**LUCIP Addendum for the  
Wetland Area at Dunbarton Bay**  
*Addendum to the Revision 1 Land Use Control Implementation Plan  
for the Wetland Area at Dunbarton Bay in Support of  
Steel Creek Integrator Operable Unit (U)*  
SRNS-RP-2023-00335, Revision 0, June 2023

# **Addendum to the Revision 1 Land Use Control Implementation Plan for the Wetland Area at Dunbarton Bay in Support of Steel Creek Integrator Operable Unit (U)**

**SRNS-RP-2023-00335**

**Figure 3. Proposed New Land Use Control Boundary and New Warning Sign Locations for the WADB**

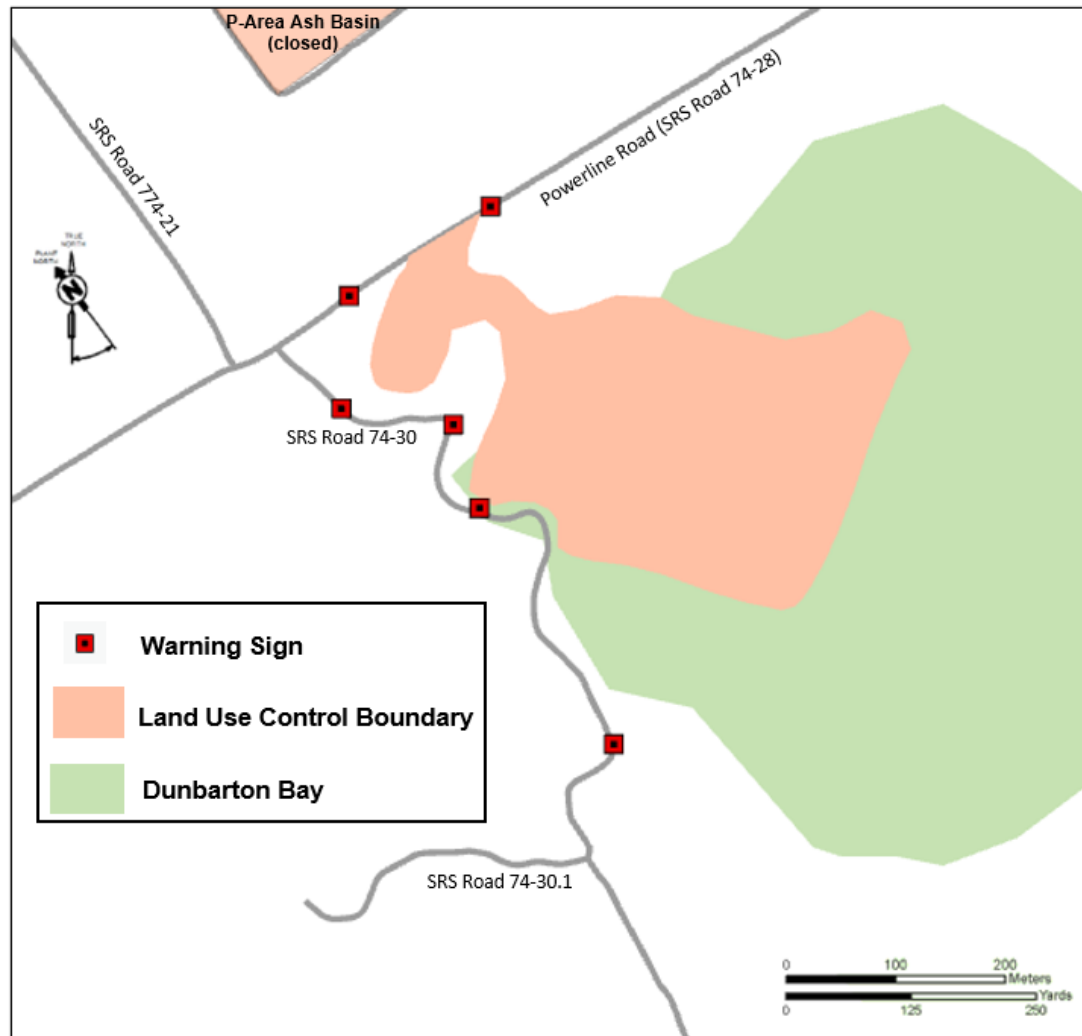
The LUCs will be implemented as described in the WADB LUCIP except with respect to the change to the LUC boundary maps and warning signs as documented in this LUCIP Addendum. The original LUC boundary map as presented in the WADB LUCIP (SRNS 2018a), Figure 2, has been revised per this Addendum as shown in Figure 3. The signs installed as described in the Post-Construction Report (PCR) (SRNS 2020) (Figure 2) will be repositioned as shown in Figure 3. Because much of the area subject to LUCs is within a wetland that is not readily accessible, warning signs will be placed along access roads near the LUC area, and all the warning signs will include a map of the LUC boundary as shown in Appendix A.
